UNITED STATES PATENT AND TRADEMARK OFFICE

APPLICATION NO.	FILING DATE	FIRST NAMED INVENTOR	ATTORNEY DOCKET NO.	CONFIRMATION NO.
10/669,745	09/24/2003	Robert J. Boisselle	1-15957	4502
1678	7590	05/31/2006	EXAMINER	
MARSHALL & MELHORN FOUR SEAGATE, EIGHT FLOOR TOLEDO, OH 43604			LAZORCIK, JASON L	
			ART UNIT	PAPER NUMBER

Office Action Summary

DETAILED ACTION

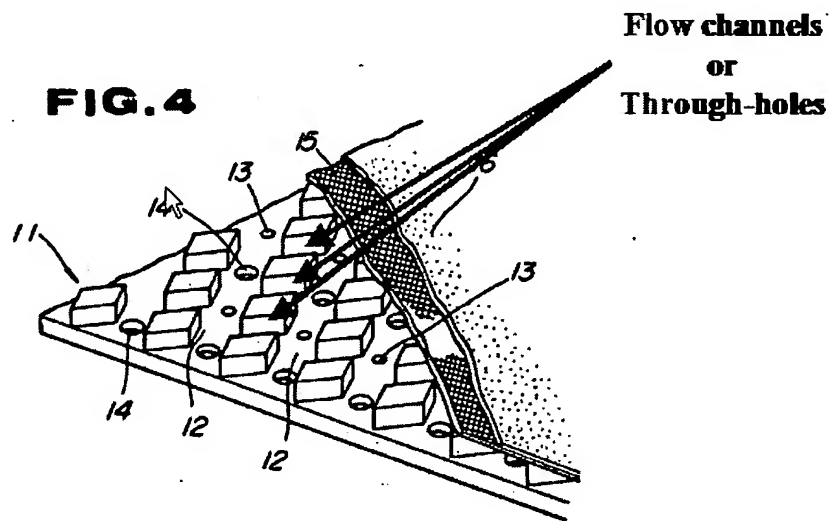
With respect to Claim 6, it is here understood that "the" groove refers to one of the set of grooves included in the claimed set of "at least one groove" in Claim 1 and as broadly depicted in the reference Figure 5. Referring to the immediate reference, Yoshizawa (C3 L65-68) defines the "raised ridges or lands for contact with the glass sheet" as having a width X ranging from 0.5 mm to 10 mm. It is therefore understood from Figure 5 that "the groove" is arranged approximately 0.5 mm to 10 mm from the edge of the glass sheet. Since the range identified by Yoshizawa overlaps with the claimed limitation that said groove is arranged 5-20 mm from the outer edge of the glass, the claimed range is anticipated by the prior art.

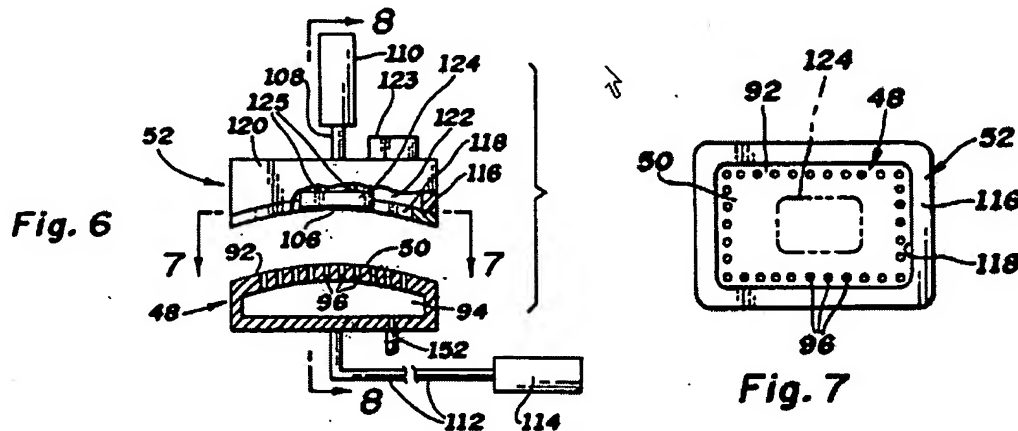
With respect to Claim 9, additional flow channels and through-holes are incorporated in the molding face of the full-face mold. Yoshizawa in the immediate reference Figure 4 makes provisions for interconnected grooves (See below figure) thus providing additional flow channels and through-holes in the area enclosed by the holes.

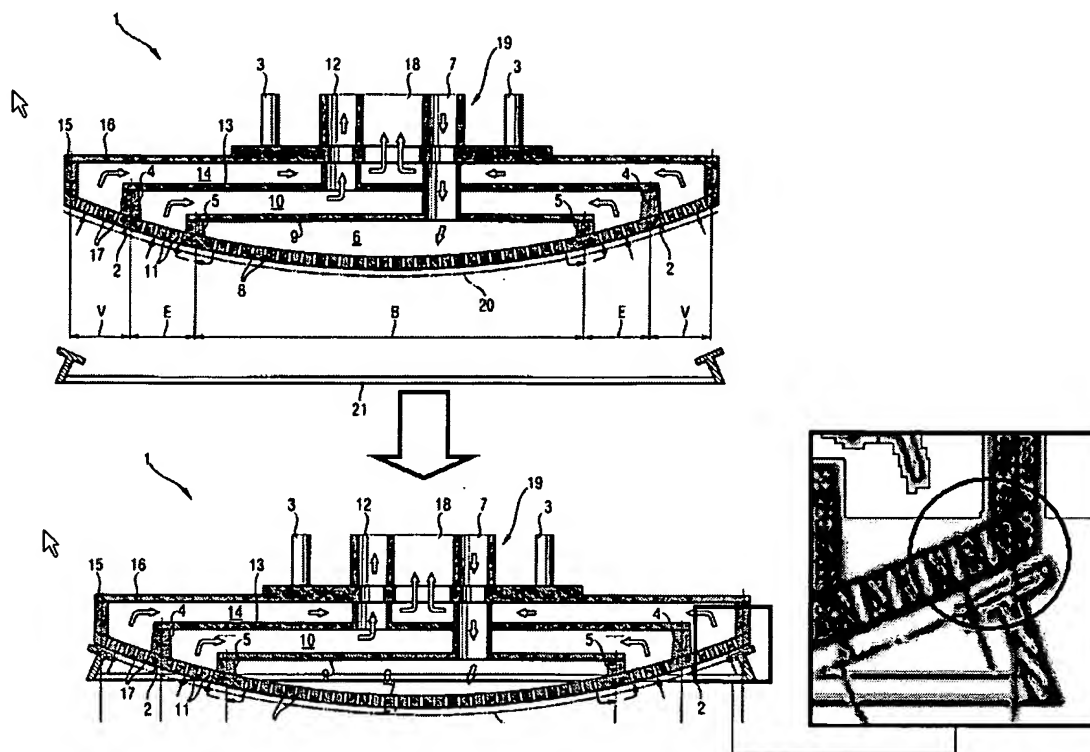
McMaster (see excerpt figures 6 and 7) presents a press bending station wherein a ring of vacuum ports (96) are provided on the face of a full-face mold (50) in an

arrangement and location "predetermined" by the ring mold (116). Specifically, the holes are arranged within the circumscribed perimeter defined by the contact area of the ring mold with the full-face mold.

Similarly, Diederer (See excerpt figure 1-upper figure) presents a full-face mold (19) with vacuum holes (17) and a complimentary annular ring mold (21). A slight modification of the Diederer figure (lower left figure) displays the disposition of the full face mold with the annular ring mold during close approach of said members during a press bending operation. The inset (lower right figure) displays the contact area between the full face mold and the ring mold. It is clear from the inset figure (black circle) that a plurality of holes emerge in the face of the full face mold in the contact area between the ring and full faced molds. In the present context, the holes are arranged on the full-face mold in an area "predetermined" by the configuration of the ring mold and more specifically by the contact of the ring mold on the full-face mold.

Both references present a peripheral arrangement of vacuum ports emergent on the face of a full-face mold and arranged in an area "predetermined" by the configuration of the annular mold either;

- 1) Within the contact area of the ring mold on the full-face mold as taught by Diederer or;
- 2) Within the circumscribed perimeter defined by the contact area of the ring mold on the full-face mold as taught by McMaster.

It would have been obvious to one of ordinary skill in the art to utilize an arrangement of vacuum holes as presented by Diederer or equivalently by McMaster in the modification of the Yoshizawa press bending station in order to optimally secure the periphery of the glass sheet during the press bending operation.
